SKANSKA	Washington State Department of Transportation I-405, Brickyard to SR 527 Improvement Project Contract No. 009727	Doc Type: RFI REV#: 0 SPEC SECTION: DATE: 06/18/2025 CRE #: BY-CRE-02874

Submittal: BY-CRE-02874_009727_RFI_00461_16.03.01_405 103E Seismic Retrofit and Widening

SKA Title and Description: 405 103E Seismic Retrofit and Widening

PIER 3. ELEVATION

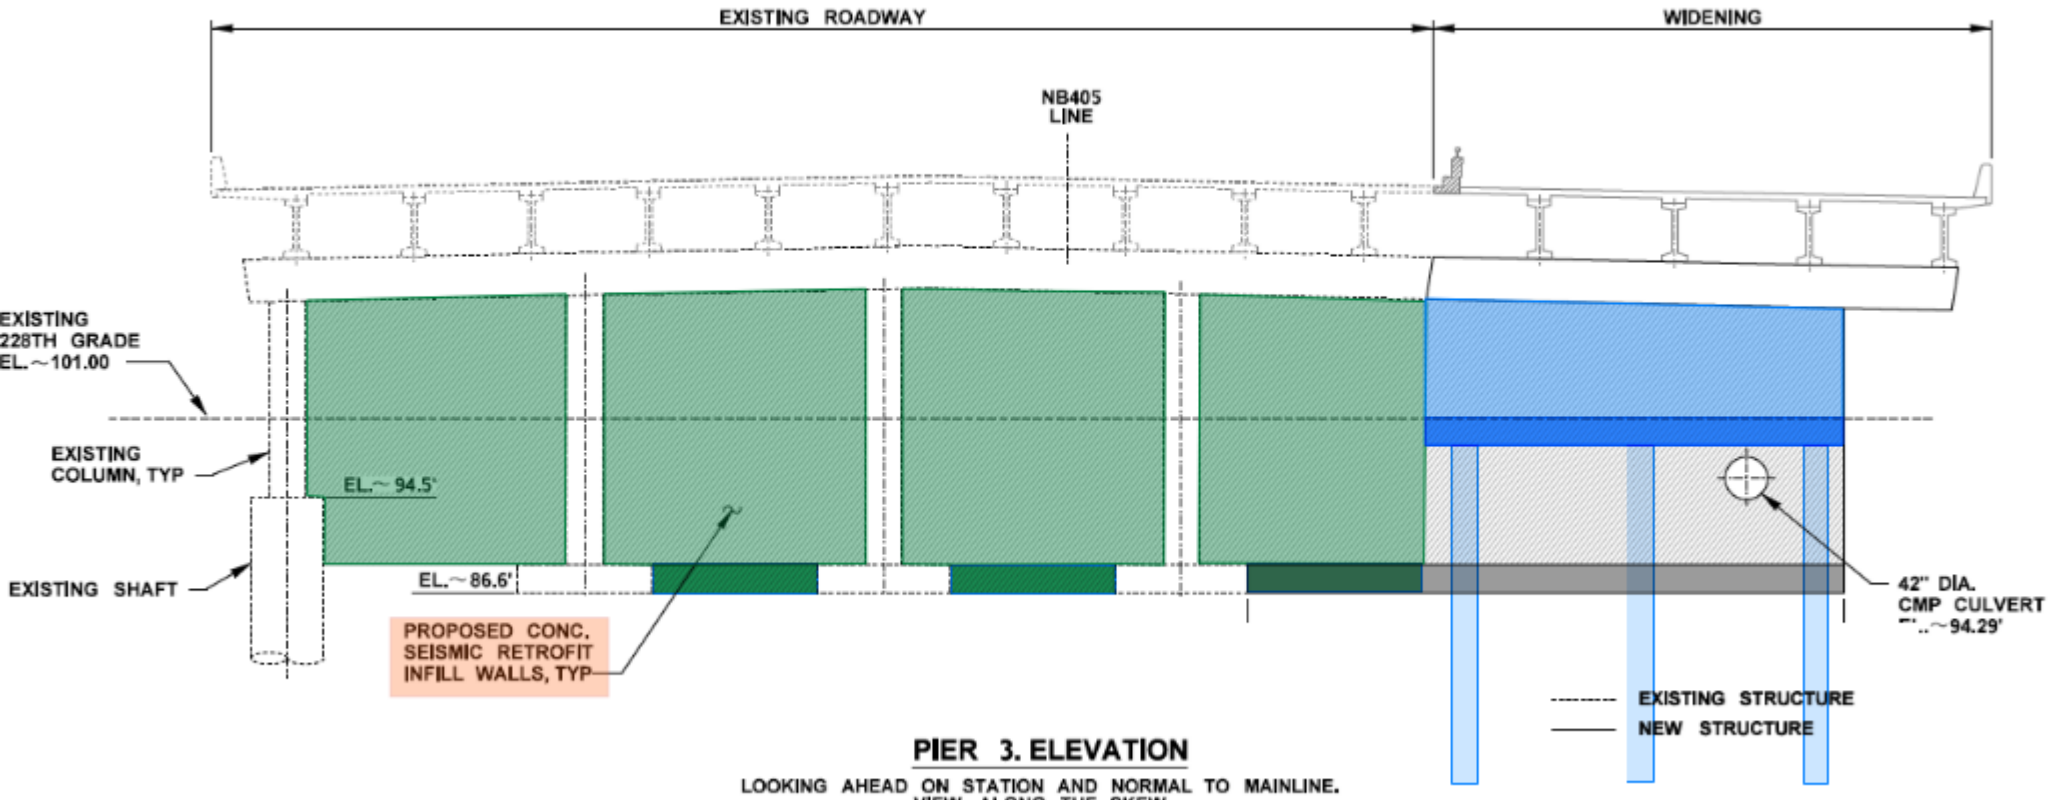
The Design-Build (DB) Team respectfully submits this Request for Information (RFI) to clarify our position regarding the structural approach for the widening of Bridge 405/103E and the protection of the existing culvert, as referenced in the ATC exhibits and contract documents.

Due to the highly environmentally sensitive protected waterway, the absence of as-built drawings, and further investigation of existing conditions, the design-build team has determined that safely protecting the existing culvert as it passes through the shear wall, as shown in the ATC exhibits, is not feasible. Instead, our proposed bridge widening approach includes installing a pile cap with a shear wall above the existing culvert, supported by small-diameter shafts to minimize impacts. We believe the "Proposed RFP Modifications" outlined in the ATC and other contract provisions support this solution, and no additional DBICs are required.

The DB Team's position is the contract documents do not require the existing substructure of 103E to be connected to the widened substructure of 103E. The superstructure of the widened portion of 103E will be structurally connected to the existing superstructure of 103E by the reinforced concrete deck and diaphragm closure strips between the existing outside girder and the new adjacent girder. The bridge widening and superstructure connection will be designed to meet the contract design requirements. The substructure of the widened portion of 103E, including pier caps, will be separate from the existing substructure and designed accordingly per the contract design requirements.

We respectfully request confirmation from WSDOT that this interpretation aligns with the intent of the contract documents and that no further DBICs are necessary for this approach.
